# Building Permit Application

I'm in receipt of the building permit (B16001258), floor plans and BAT Plan for Warfield Pond Overlook, Lot 3.

**RE: Building Permit # B16001258**  
**3411 Warfield Pond Overlook**  
**Glenwood, MD 21738**

**From:** Oswald, Hank  
**Sent:** Thursday, April 14, 2016 3:13 PM  
**To:** BOBCORBETT@WILLIAMSBURGLLC.COM; CHRISWINE@WILLIAMSBURGLLC.COM  
**Cc:** Zach Fisch <zfish@FSHERI.COM> (zfish@FSHERI.COM)  
**Subject:** Warfield Pond Overlook\_Lot 3

Drawing: FINISHED BASEMENT PLAN  
Project: WILLIAMSBURG GROUP  
WELLINGTON  
WAREFIELD POND LOT 3

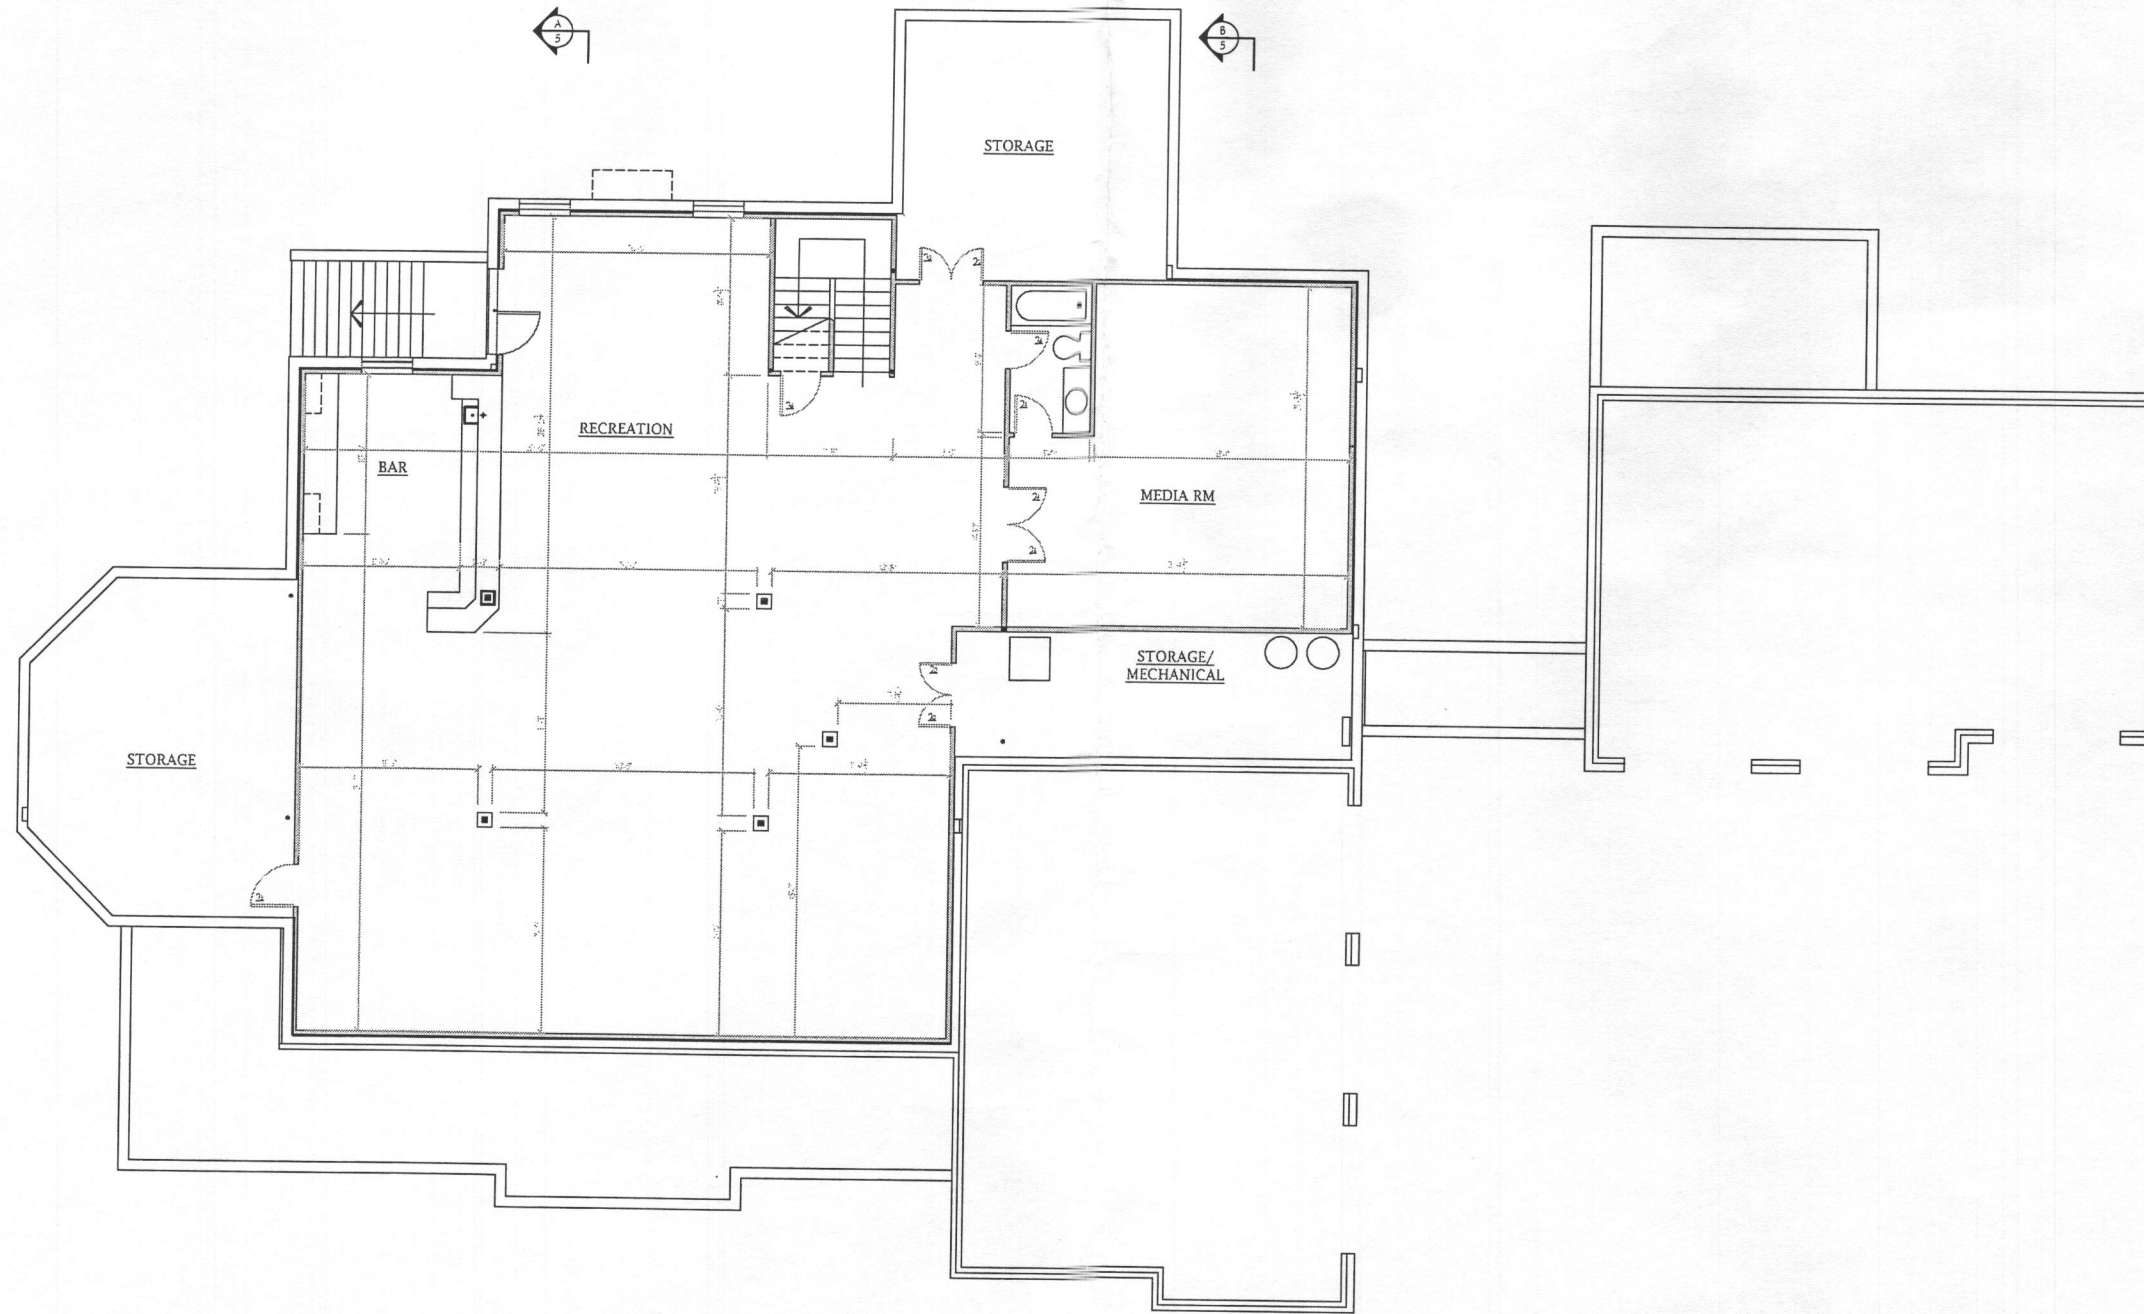
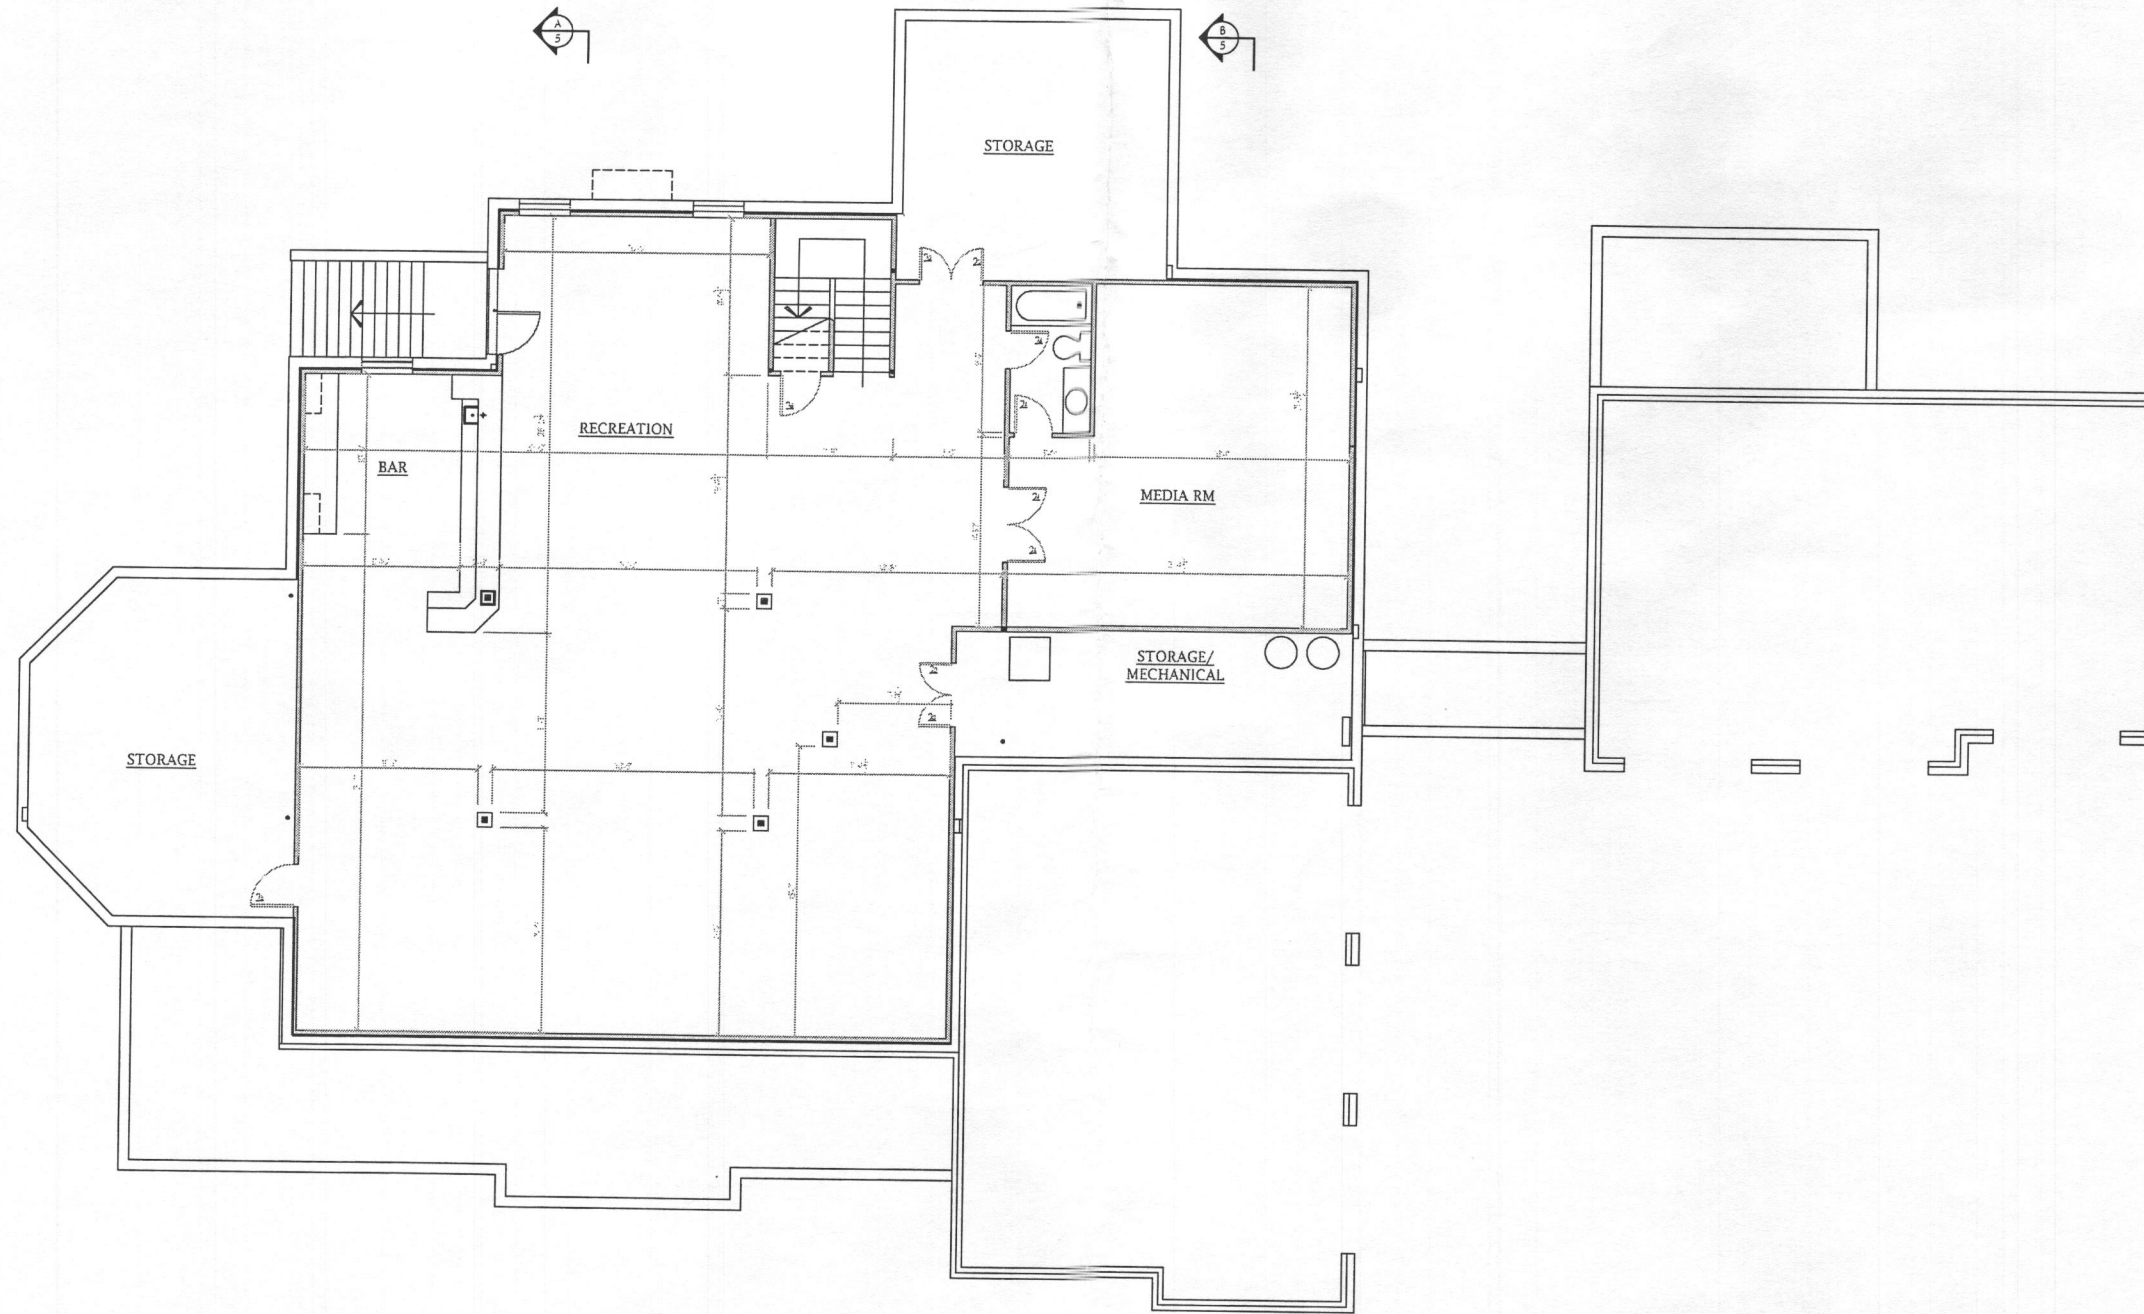
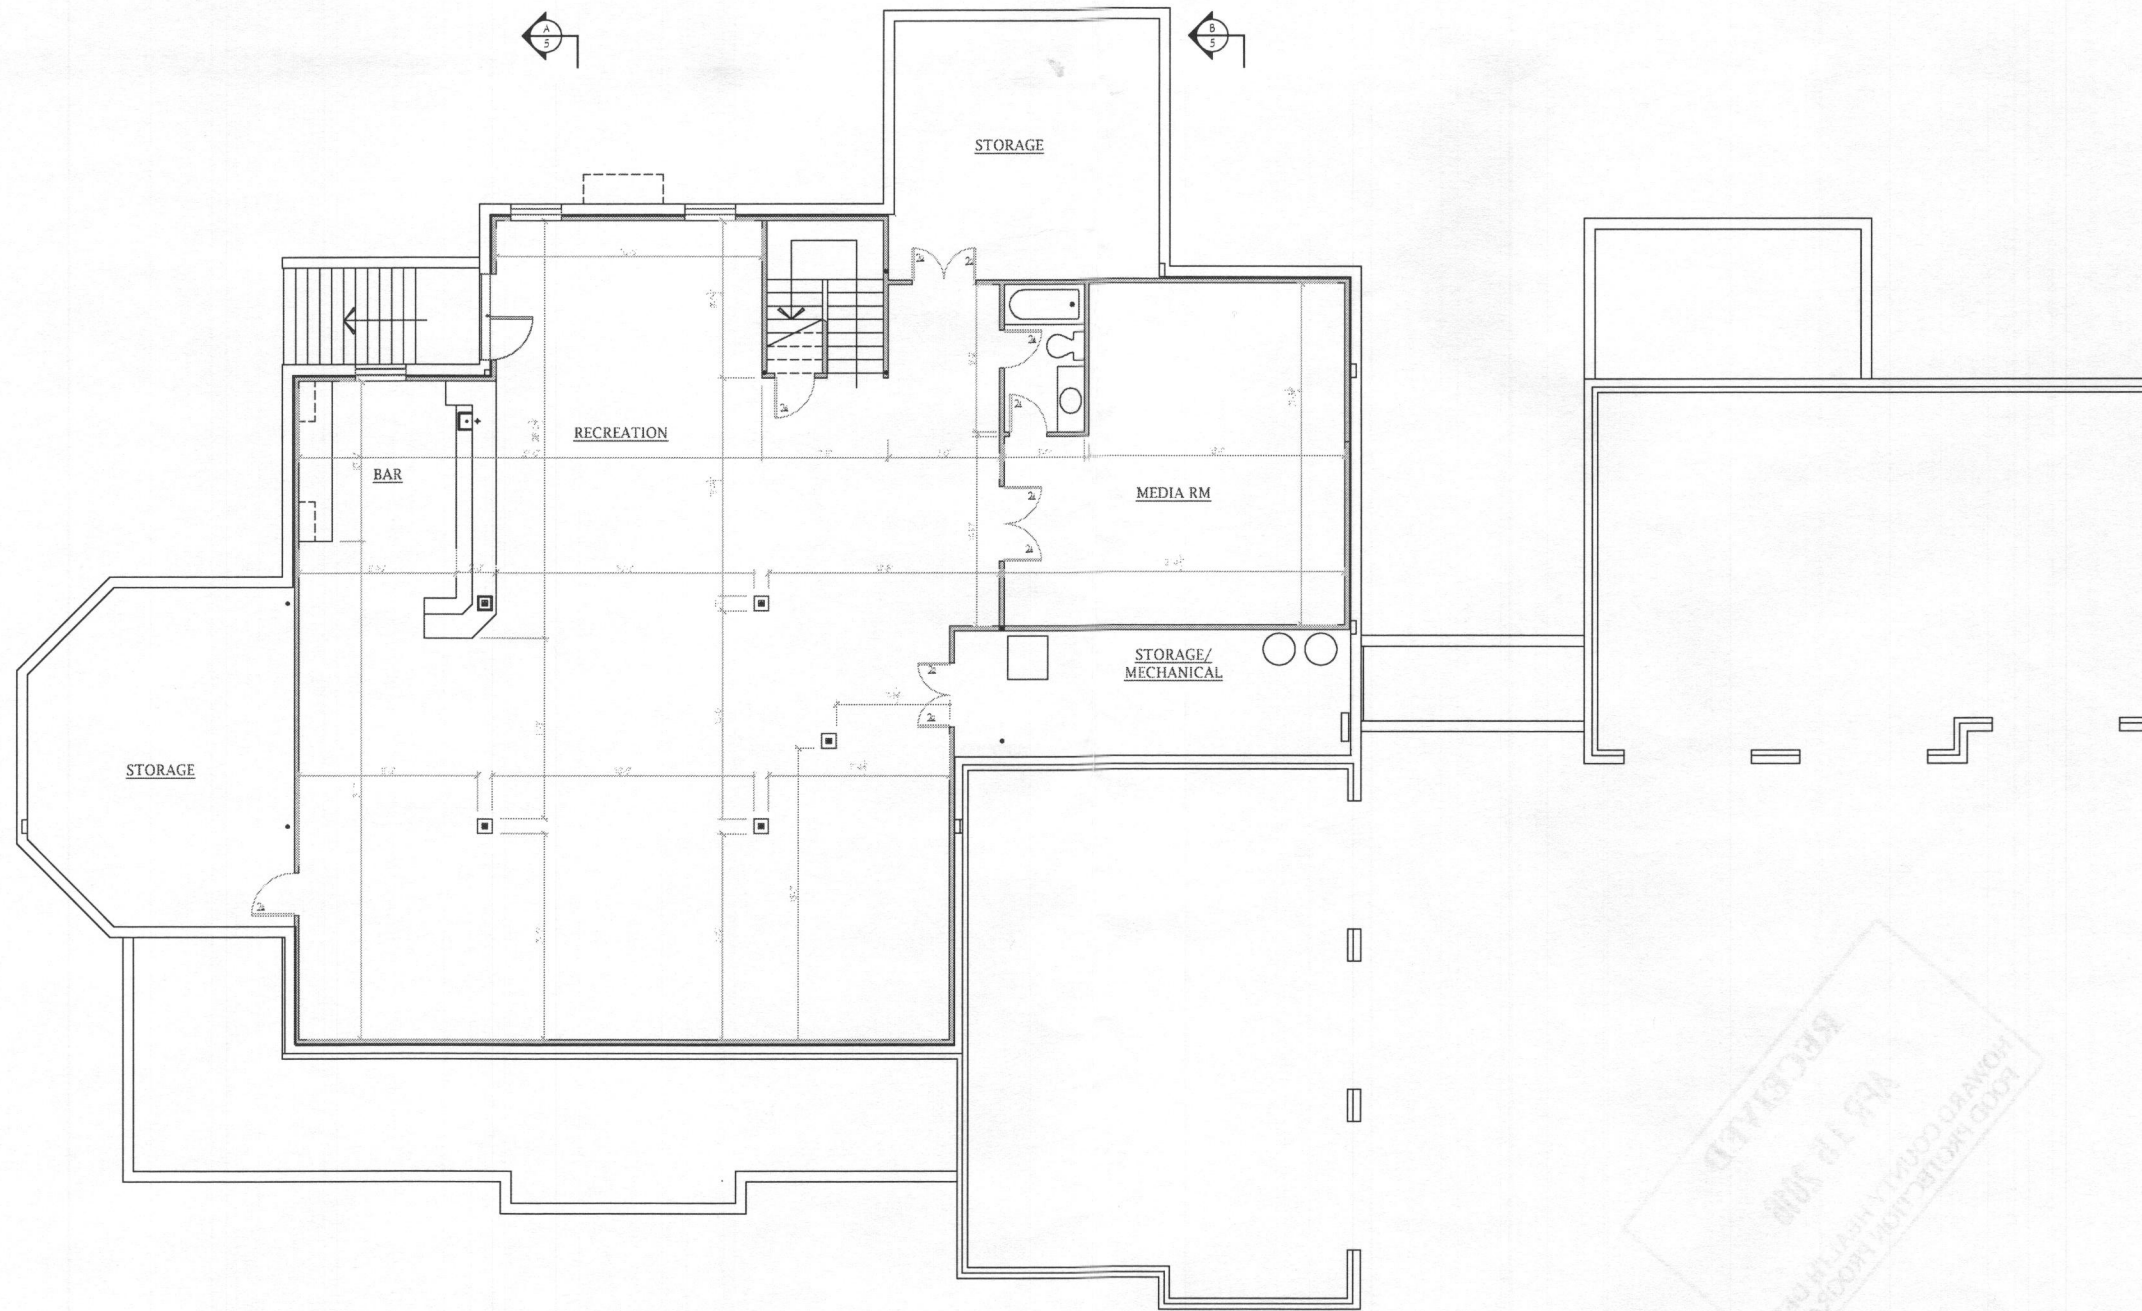
This is a very different definition than that used by DILP. I will relocated the doors to the media room so that the access to the bathroom is public and not specific to the media room. You can't expect the owners to use a theater room without being able to close the doors to the room, therefore just a 4' opening is not possible.

Attached, please find a copy of the Section 3.801 regarding bedroom definition. A room doesn't need to include a closet in order for it to be considered a bedroom. The media room in the basement and the library room on the first floor both have a window, door and direct access to a full bathroom and therefore are considered bedrooms. If the doors to the media room were to be removed, making it a permanent 4 foot wide opening then it would not be considered a bedroom and we are back to 5.

REVISED 4/15/16
